Date: 25.02.2016

Department: SAV

Red Led 10% always ON

Diode to replace

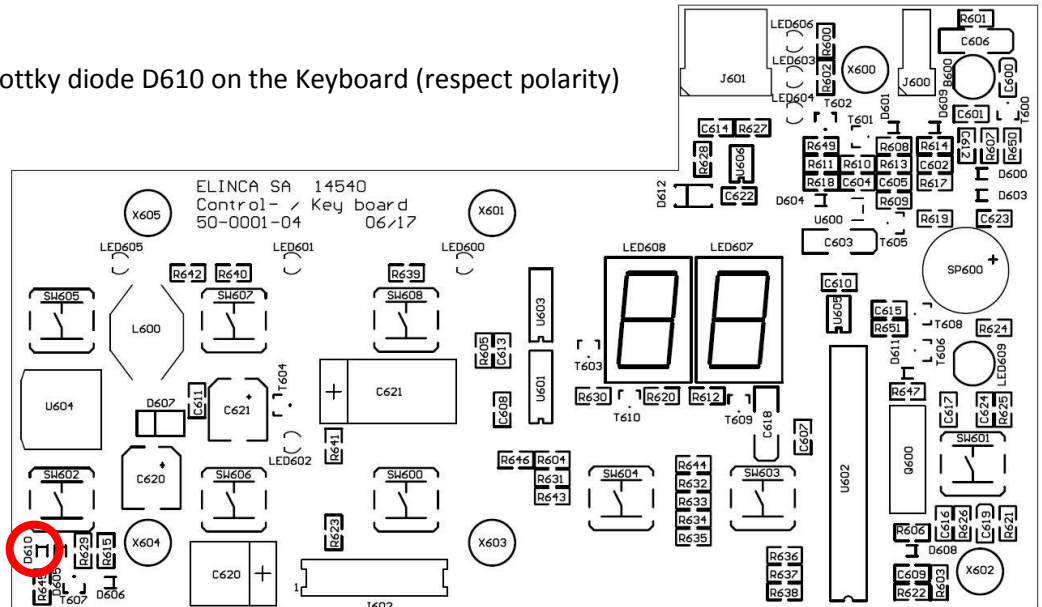
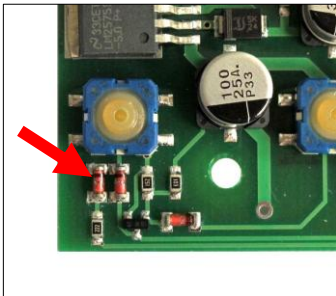
Due to a defective Schottky diode, in some rare case, you can find this issue :

Even if the Ranger RX unit is OFF, the red Led 10% could stay ON.

We suggest to replace the Schottky diode D610 on the Keyboard (respect polarity)

If you find this issue, please fill and send a warranty request form to obtain the replacement free of charge of the Diode Schottky 0.2A 30V TMMBAT42 **105.147**.
